RUHE SUBDIVISION
MAJOR SUBDIVISION #2013-201
ATTACHMENTS

TO: PLANNING COMMISSION
FROM: GREGG ADAMS, PLANNER
SUBJECT: RUHE SUBDIVISION
MINOR SUBDIVISION #2013-201
REQUEST FOR MAJOR SUBDIVISION REVIEW

SUBJECT: South Whitehall Township
Ruhe Minor Subdivision #2013-201
Preliminary/Final Plan Review

Re: Robert Ruhe
Land Development #2013-201
Review of Preliminary Plan
SSM File 103400.0036

LANDSCAPE PLAN

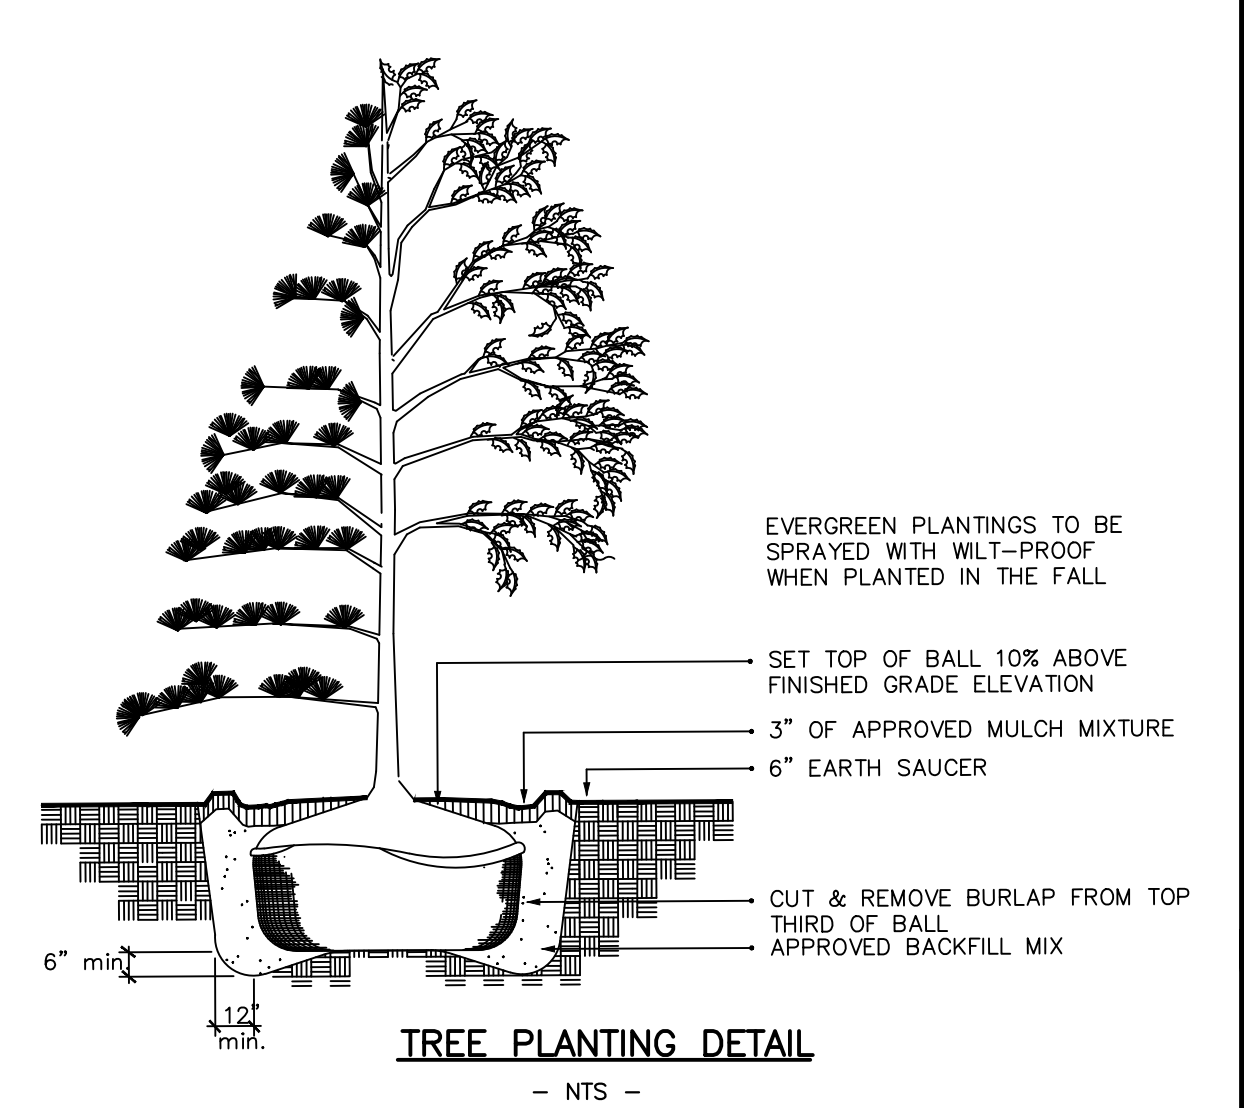
1. The Commission recommended that the applicant verify the current Township Clear Sight Triangle requirements and that the Red Maples be replaced with a species resistant to Verticillium Wilt.

The Commission recommended that the applicant verify the current Township Clear Sight Triangle requirements and that the Red Maples be replaced with a species resistant to Verticillium Wilt.
